BAYVIEW FLOOD MAPPING RESPONSE

Adopted flood study, flood mapping and Estuary Hazard Map

Figure 1: Adopted flood mapping for the Bayview locality showing mapped flood behaviour and PMF level labels in the external overland flow / road corridor. The proposed development site / footprint is not shown within the mapped flood extent.

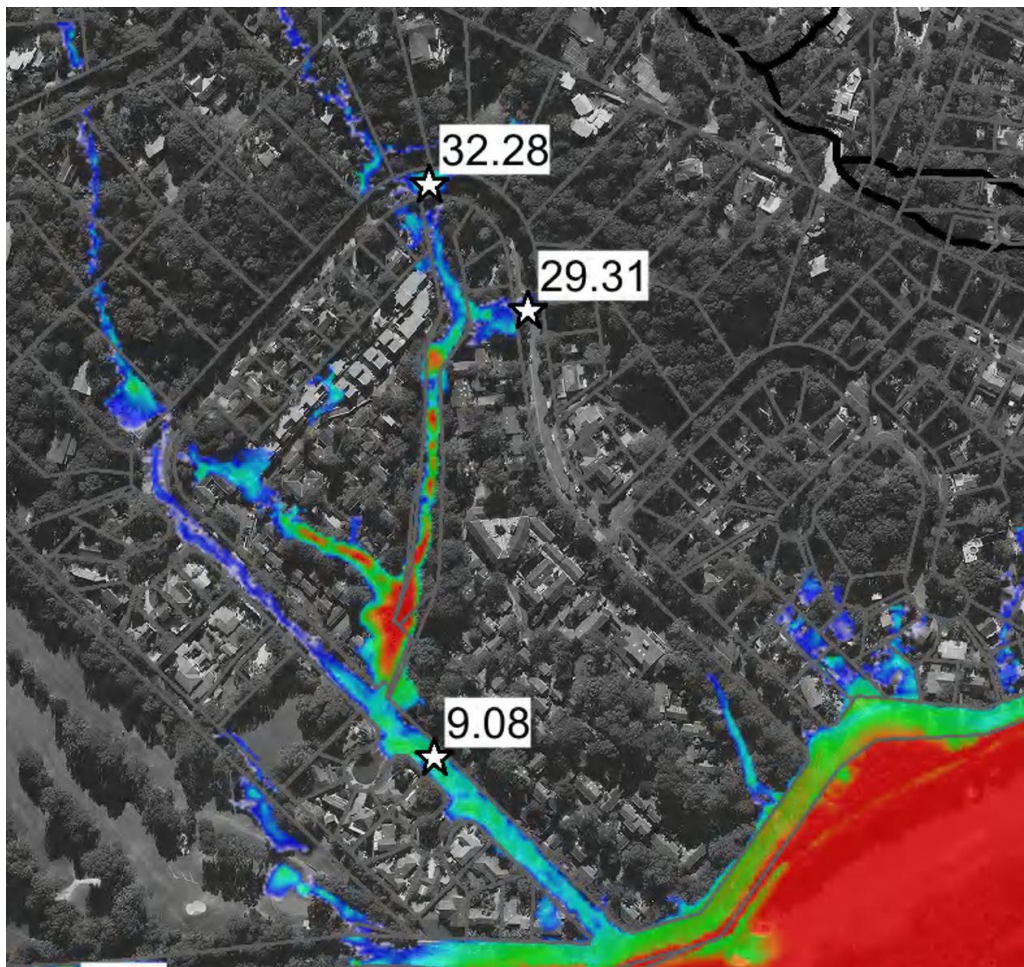
The important distinction for the present development is that the mapped PMF flow paths and PMF flood level labels are shown along the external drainage / overland flow corridors and low-lying road areas. The proposed development footprint is not shown as being inundated by the mapped flood extent. Accordingly, the off-site PMF labels should not be treated as flood levels applying to the proposed building platform.

The lowest proposed development level is RL 20.48 m AHD. However, because the development footprint is outside the mapped flood extent, the primary assessment issue is not a comparison between the floor level and off-site PMF spot levels. The PMF labels shown on Figure 1 are location-specific outputs along external flow paths and should not be applied as a uniform flood level across the site. The relevant conclusion is that the mapped PMF does not extend to the development footprint.

Matter raised	Project position	Proposed close-out response
Need for FIRA	The development footprint is not shown within the mapped flood extent, including the PMF flood mapping.	A standalone FIRA is not proportionate or necessary. Provide a targeted flood mapping response and survey overlay instead.
PMF information	PMF levels shown on the attached mapping are location-specific outputs along external flow paths and do not apply uniformly to the site.	Identify that the mapped PMF extent does not encroach on the proposed development footprint and that the off-site labels are not building platform flood levels.
Floor and carpark levels	Lowest proposed development level is RL 20.48 m AHD and is outside the mapped flood extent.	Confirm all habitable floors, carpark entries and critical services are located outside mapped flood affectation.
Overland flow	Mapped overland flow is external to the development footprint and follows established drainage / road corridors.	Confirm that the proposal does not obstruct, divert or fill mapped overland flow paths. Include a survey / drainage plan overlay if required.
